AGENDA
CITY OF YAMHILL, CITY PLANNING COMMISSION MEETING
PUBLIC HEARING
City of Yamhill Council Chambers, 205 S Maple St., Yamhill, OR 97119 & Zoom
Thursday, April 13, 2023
6:30 PM

STAFF REPORT

SUBJECT: Planning File — Gas Station/Convenience Store (DR 23-01)

DATE: March 28, 2023

FRONT ELEVATIONS 32' 1'-0" @ 24 x 36

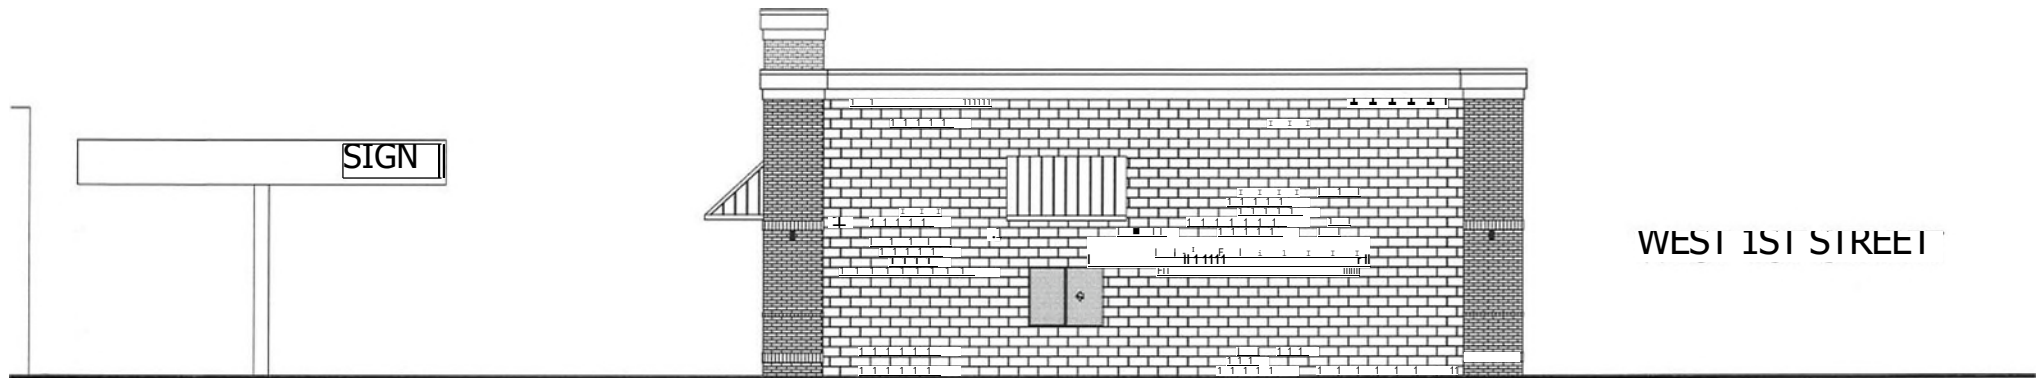
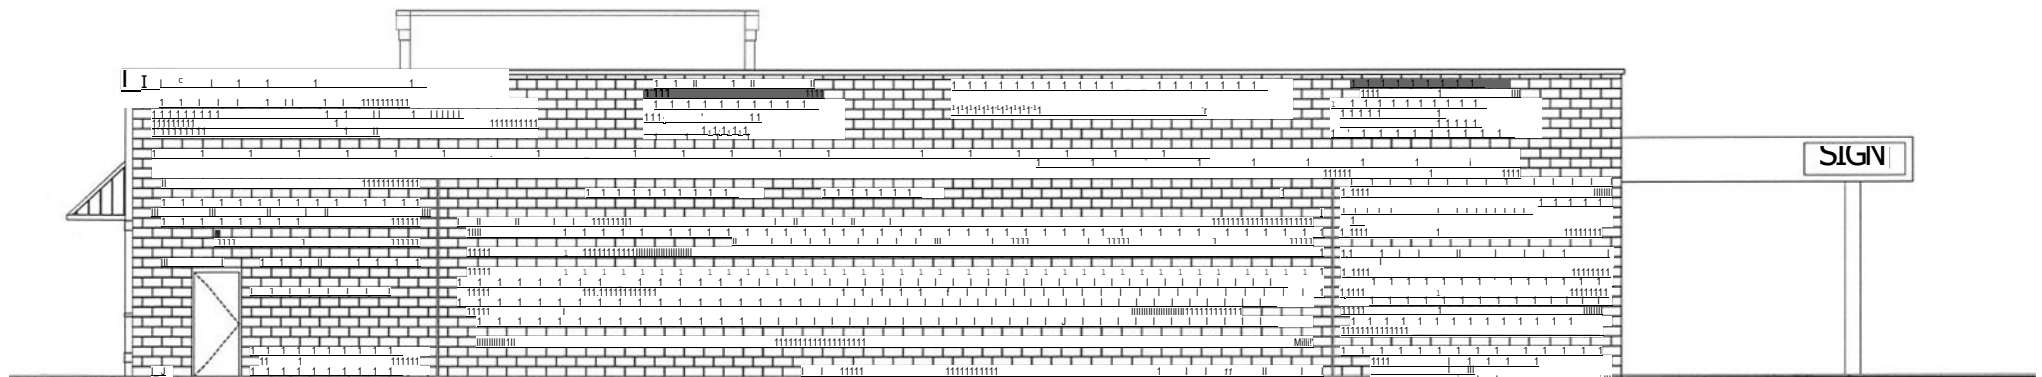
FINDINGS: The building complies with the 0-foot setback requirement on Maple Street. Within the block, the "Front Elevation Plans" show the roof line is approximately equal to the structures to the south.

The submitted "Front Elevation Plans" also shows the adjacent four buildings having their main entrance facing the street. In contrast, the proposed building's Maple Street frontage is a brick wall without an entrance or windows. This is in stark contrast to the existing structures.

3. Design/Facade — The submitted plan comparing building elevations along the block showed the main building entrances fronting Maple Street. Not so with the proposed structure. Although allowed, this raises the question as to whether the design is ". . . similar in character and design with existing structures." Further, it is not just the doors facing the street, but the frontage includes significant window features, again something that is lacking in the proposal.
